UNITED STATES PATENT AND TRADEMARK OFFICE

Office Action Summary	Application No. 10/812,846	Applicant(s) SUZUKI, TOSHIHIRO	
	Examiner David J. Makiya	Art Unit 2875

DETAILED ACTION

Figure A: Ohtake et al.: Irradiation Angle and Linear Projected Portions

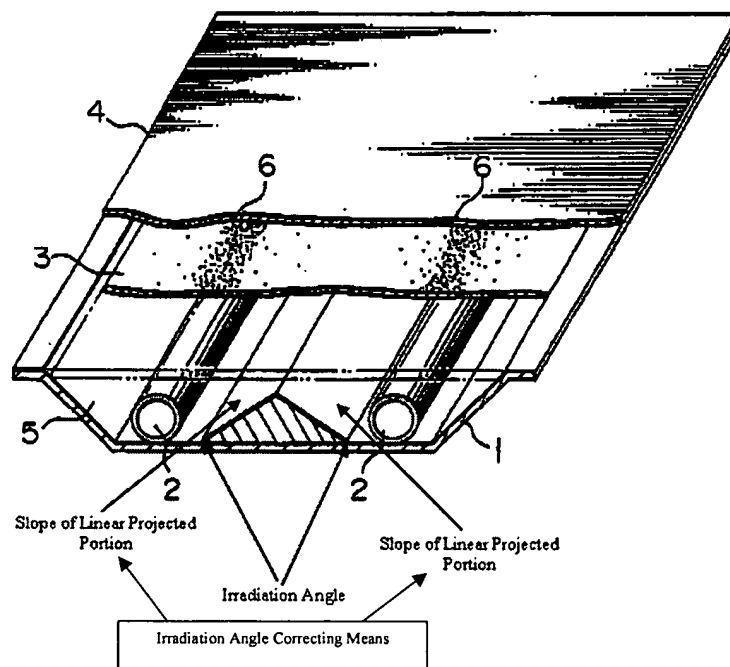
With respect to claims 3 and 5, the applicant's admitted prior art teaches a surface lighting device comprising a surface light source in which linear light sources having light-emitting elements, which correspond to respective colors among combinations of plural colors including at least three primary colors of light, arranged in series are arranged in a predetermined order, a reflection plate which is laid so as to fill spaces among the light-emitting elements constituting the linear light sources, a substrate on which the surface light source and the reflection plate are set, and a diffusion plate which the surface light source and the reflection plate are set, and a diffusion plate which is located above the surface light source and the reflection plate. However, the applicant's admitted prior art fails to teach the substrate having linear projected portions nor does it teach an irradiation angle. Ohtake et al. teaches a surface lighting device comprising a substrate which has linear projected portions arranged at a fixed interval wherein each of the linear light sources is arranged on only one slope of the linear projected portions arranged at the fixed interval on the substrate (see Figure A), and an irradiation angle, at which an amount of light of the light-emitting elements corresponding to at least one color among the plural colors is maximized according to the interval of the linear projected portions and an interval between the diffusion plate and substrate, is set according to an

angle of the slopes of the linear projected portions (Figure A). Because the references teach the structure of the claimed surface lighting device, the references would also teach that the interval L, the interval H, and the irradiation angle such that a relation of $L \leq 2 \times H \times \tan(\text{irradiation angle})$ (irradiation angle at which an amount of light of the linear light sources is maximized) is satisfied. It would have been obvious to one of ordinary skill in the art at the time of the invention to modify the device with the teachings of Ohtake et al. because the linear projected portions would increase the light intensity by adjusting the irradiation angle.
